S-92[®] HELICOPTER

ASB 92-25-026

SUBJECT: EQUIPMENT FURNISHINGS – Side Facing Utility Seat – One Time Inspection of Side Facing Utility Seat (MBCS12410AA001) and Observer Seat (MBCS12200, and MBCS7301-2) and Repair with New Tube Assembly if Necessary

SPECIAL INFORMATION LEAFLET No. 831

Figure 1 – Position of Fastener, 25mm Hook P37689 on Tube Assembly, Back Main MBCS12834

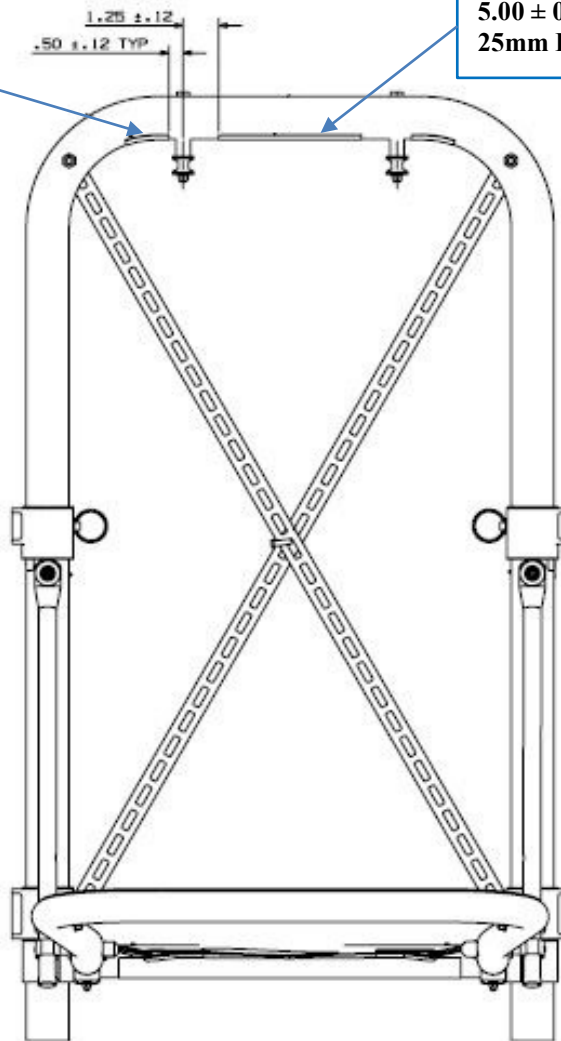
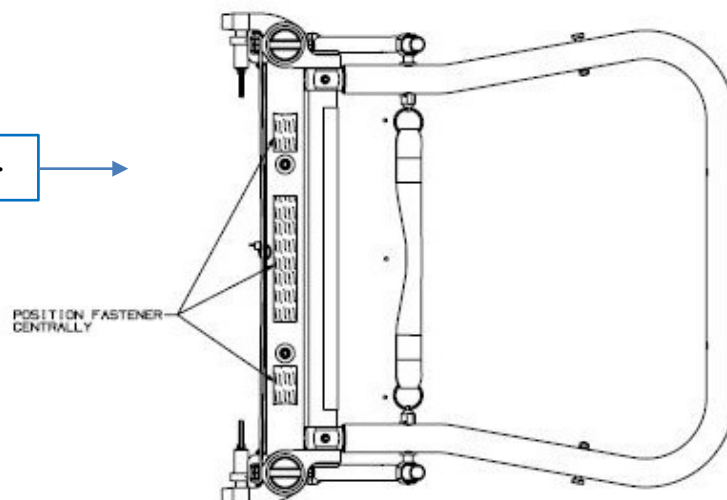
D2.6.1 With reference to Figure 1 below, attach fastener, 25mm hook P37689 to underside of the top of the main back tube assembly.

1.50 ± 0.12 long
Fastener, 25mm
Hook (P37689) 2
places.

Figure 2 – Position of Warning Ident Label MBCS4148 (Typical)

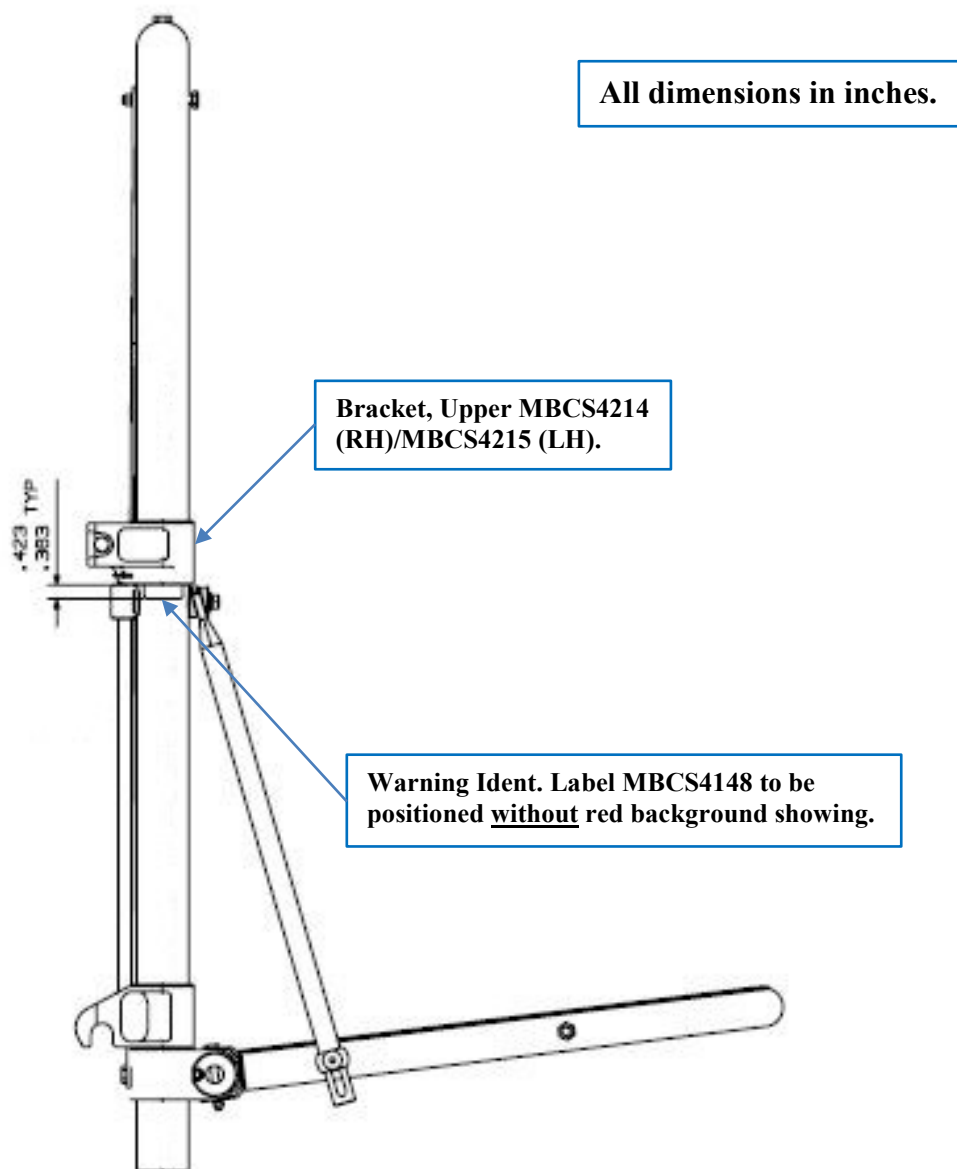
D2.6.2 With reference to Figure 2 below, attach warning ident label MBCS4148 to either side of the main back tube assembly.

Figure 1 – Position of Fastener, 25mm Hook P37689 on Tube Assembly, Back Main MBCS12834

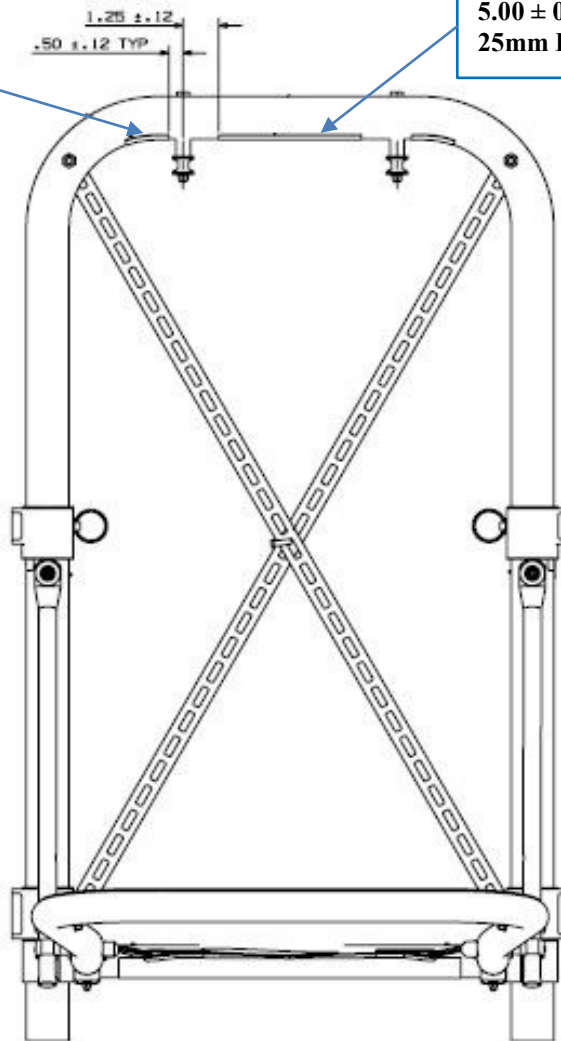
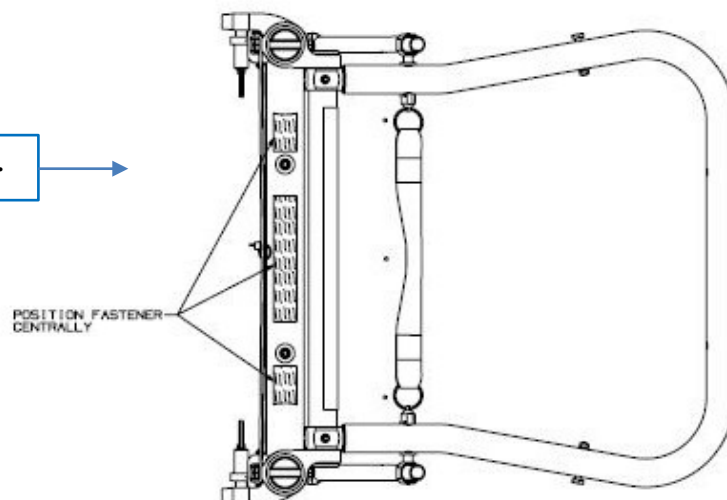
D2.6.1 With reference to Figure 1 below, attach fastener, 25mm hook P37689 to underside of the top of the main back tube assembly.

1.50 ± 0.12 long
Fastener, 25mm
Hook (P37689) 2
places.

5.00 ± 0.12 long Fastener,
25mm Hook (P37689).

Figure 2 – Position of Warning Ident Label MBCS4148 (Typical)

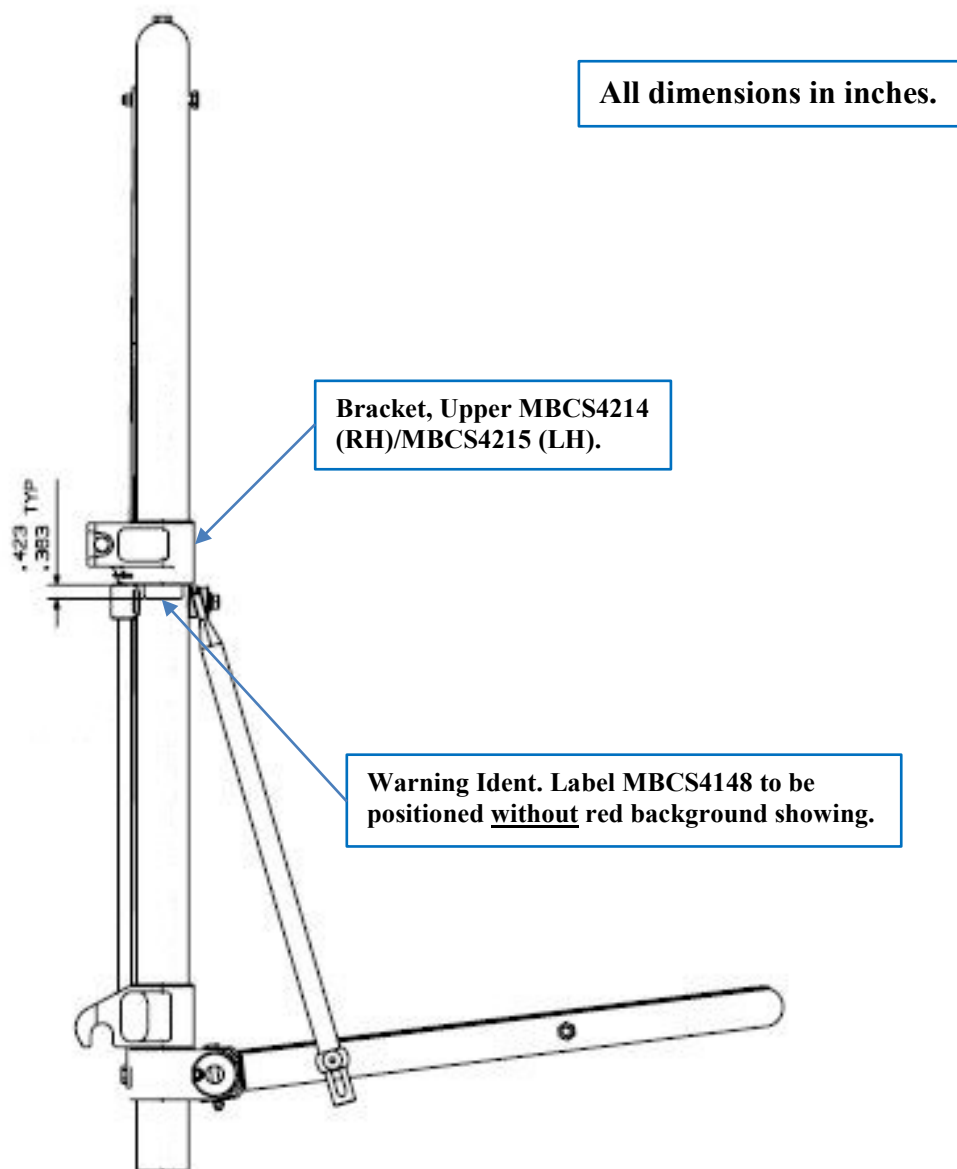
D2.6.2 With reference to Figure 2 below, attach warning ident label MBCS4148 to either side of the main back tube assembly.
